**Correspondence Between
Staff and Applicant**

Case Reference No: 4-DR-2015 Raintree Drive Extension

RE: 4-DR-2015
Raintree Drive Extension

Subject	Raintree Drive Final Design (Scottsdale Road to Hayden Road) – Progress Meeting
Date	Wednesday, February 11, 2015
Time	10:30 – 11:30am
Location	City of Scottsdale (Agave Conference Room)
City of Scottsdale Project No.	SA01A

SEGMENT 2 - OPTION 1:
MEDIAN ROLL CURB WITH 7' MEDIAN (1.5' DG REQUIRED BACK OF ROLL CURB)

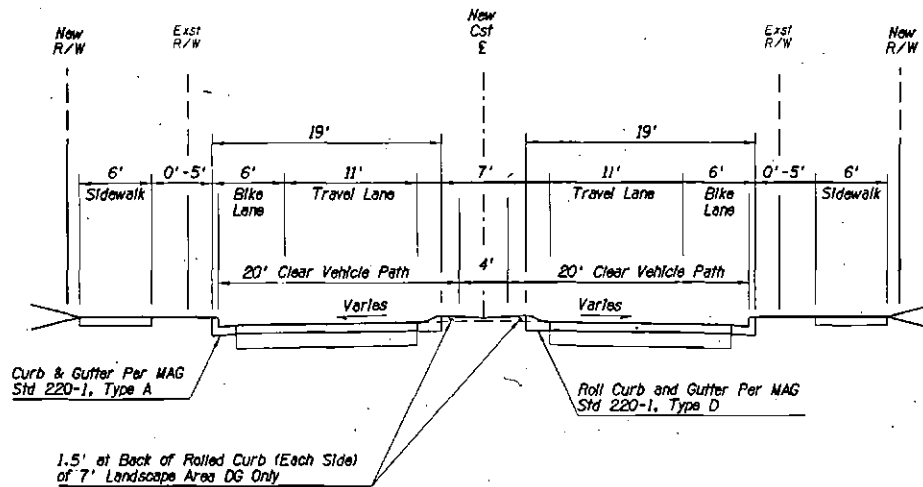
- 2. Feedback From Chief – Need 20' both directions of travel
 - a. Typical section options (See exhibits)
 - 3 Typical section options for Segment 2 were presented for discussion (see attached)

- All options included roll or mountable curb with impacts to useable landscaping space in either the median or sidewalk buffer in order to meet the 20' clear vehicle path requirements

- It was determined that option 1 was the least desirable option as it provided little opportunity for landscaping in the median
 - It was determined that both option 2 and 3 would be used within Segment 2 with Mountable Curb and Gutter (Type E) (COS Std Dtl 220-2) on the outside lanes

SEGMENT 2 - OPTION 2:
OUTSIDE ROLL CURB AND MEDIAN SINGLE CURB WITH 7' MEDIAN (1.5' DG REQUIRED BACK OF ROLL CURB)

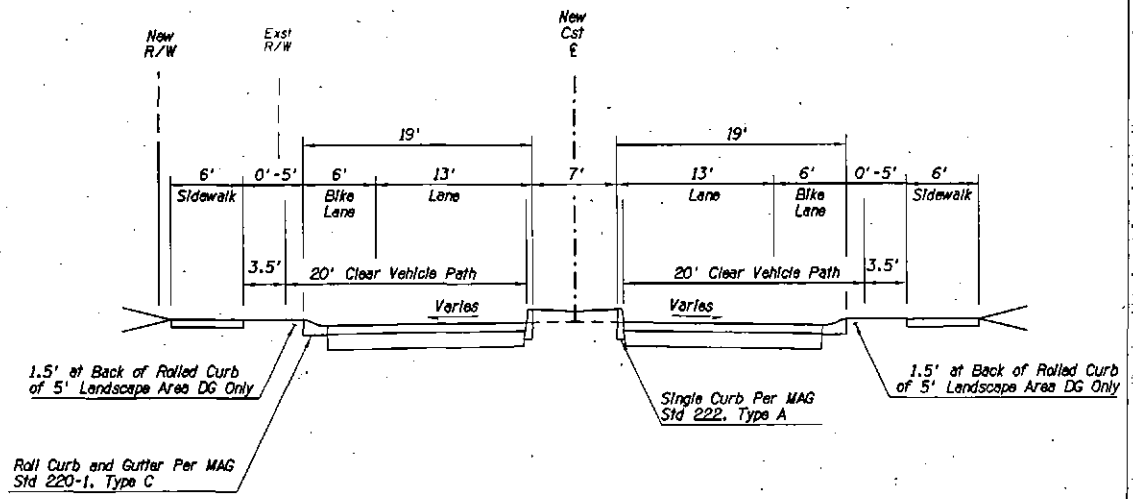
- Option 2 (7') median will be used on raised median sections along Raintree Dr from the Redfield Rd roundabout to Evans Rd
 - Option 3 (10') median will be used on raised median sections along Raintree Dr from Evans Rd to the Hayden Rd roundabout

4. Chief Ford has agreed to a 20' clearance on the project corridor. Please see attached meeting minutes (dated 2/11) regarding confirmation on this allowance. He has agreed that a 20' clear space width requirement is sufficient. Typical has been updated to include mountable curb and landscape clear areas in order to meet this clear space requirement.
5. The design team will comply and the roundabouts will be updated as design progresses and include mountable curbs where needed to meet the 20' clear width.
6. The design team will comply and all plan submittals will include demonstration at roundabouts of the minimum commercial turning radii (49' & 55') in conformance with the Design Standards & Policies Manual Section 2-1.801(5).
